**RE: 2017/4156 – ATHLONE HOUSE, HAMPSTEAD LANE, LONDON, N6 4RU**

**APPLICATION FOR A NON-MATERIAL AMENDMENT UNDER 96A, TOWN & COUNTRY PLANNING ACT 1990**

Figure 2: Extract from drawing no (817)140\_PL01 showing the proposed relocation of the AHU onto the roof and the location of the dormer access points

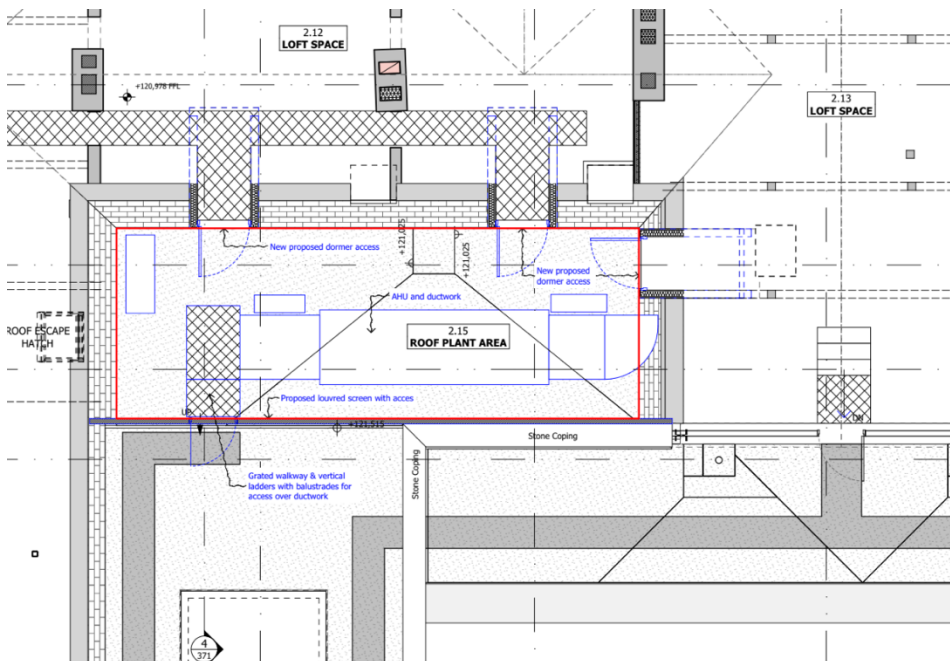
The alterations proposed in this application are shown in detail on the plans below. The primary change is the relocation of the Air Harvesting Unit (AHU) and associated ductwork from inside the loft space to the open internal flat roof area. A louvred screen is also proposed across the front of the AHU that would mitigate the visual impact of the change from the north facing tower window and bedroom 6. The location of bedroom 6 on the east side of the house means that the visual impact of the proposal would be limited anyway due to the adjacent raised loft space. To provide sufficient access for the maintenance and servicing of the equipment, a series of dormers are proposed that would allow for full height access in and out of the loft space.

Figure 3: Extracts from drawing no (817)370\_PL01 showing elevations for the proposal. The dormer access points into the loft are clearly identified and the lower image shows the proposed louvred screen to reduce the visual impact

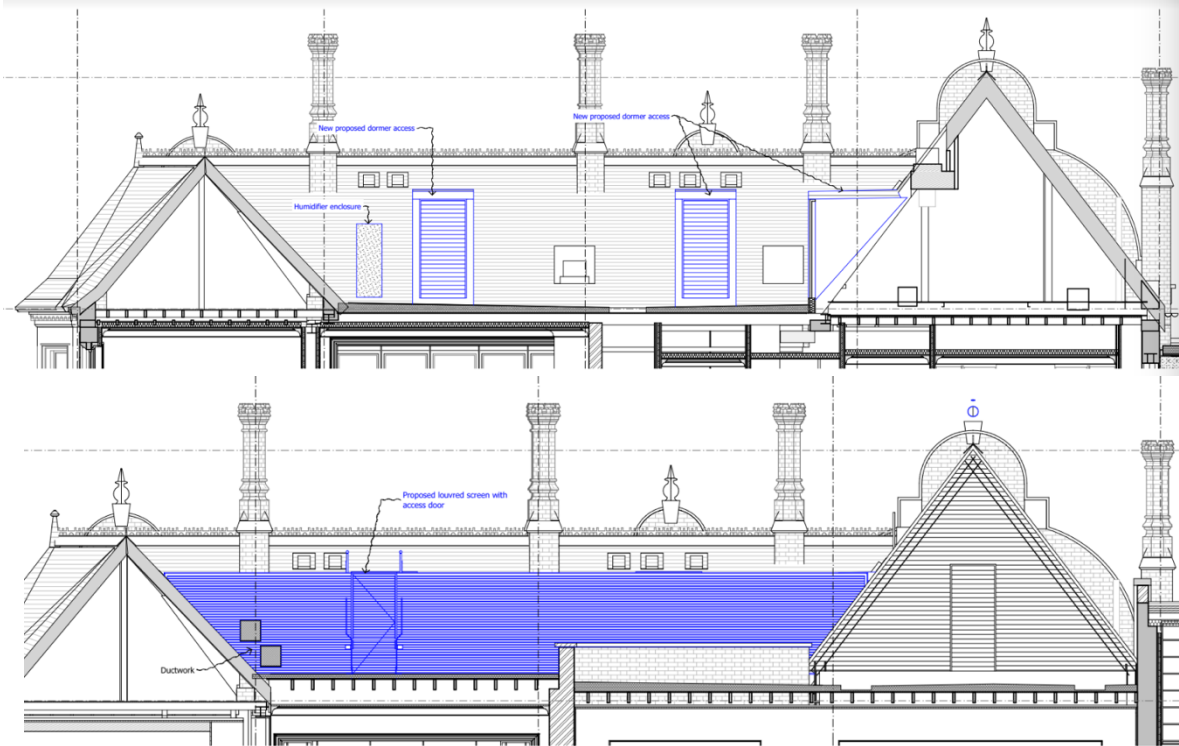
Figure 3 is an extract from the detailed sections of the proposals (refer to drawing no (817)370\_PL01 and (817)371\_PL01) which demonstrates how the dormer accesses would be subservient to the surrounding roof ridge height, and, along with the louvred screen, which extends across this part of the roof space, there would be a limited visual impact on the house.
